UN Regulation No. 55 (Mechanical couplings)

Proposal for the 03 series of amendments to UN Regulation No. 55 (Mechanical couplings)

Submitted by experts from Austria and the Netherlands *

"Annex 3

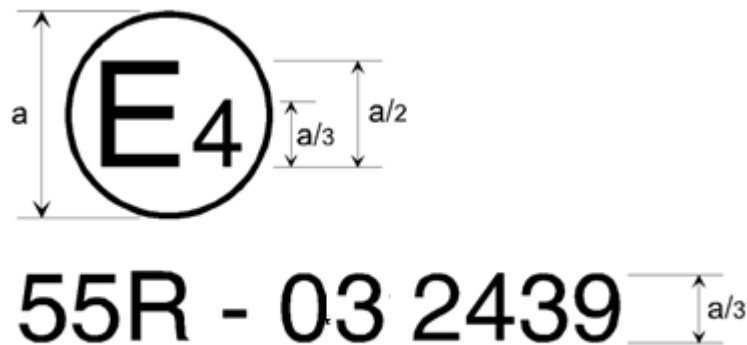
The mechanical coupling device or component or vehicle bearing the approval mark shown above is a device or component approved in the Netherlands (E 4), under approval number 2439, meeting the requirements of the 03 series of amendments to this Regulation.
